TECHNICAL MEMORANDUM

SUBJECT: Hydraulic Model Evaluation of Diaz Residence Riparian Vegetation Planting Plan

Memo and Model Revisions Made in Response to Comments

The March 4, 2021 technical memorandum was revised as shown herein to respond to comments of Benjamin Hwang, Santa Clara Valley Water District contained in the April 30, 2021 letter to Patricia Diaz from Colleen Tsuchimoto, County of Santa Clara Planning Department:

APPENDIX C-2

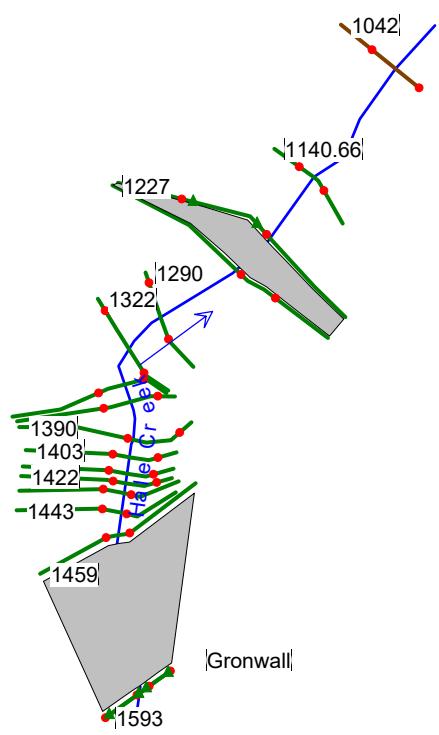
6.(c) – The downstream reach lengths in the geometry files were revised so that none of the cross-section cut-lines displayed in the geometry editor cross one another. This was accomplished by editing the fifth-point Schematic Y values in the XS Cut Lines Tables for STA 14+29 and STA 14+43 in the GIS Tools menu, and making corresponding measured revisions to the right overbank downstream reach lengths in the Cross-Section Data editor for STA 14+59, STA 14+43, and STA 14+29. See appended screenshot of geometry editor appended to this memo (Appendix C-1).

Revising the XS Cut Line coordinates and right overbank downstream reach lengths to produce an agreeable graphical representation of the geometry did change the model input data but did not change any of the model outputs referred to in the memo because only the highest flows analyzed (e.g., 100-year flow) were high enough to produce flow in the model-designated right overbank areas, and the changes were marginal and did not change the model computed water surface elevations, velocities, or shear stresses. See appended table showing that the revised model produces the same model output as the original model documented in the March 4, 2021 memo (Appendix C-2).
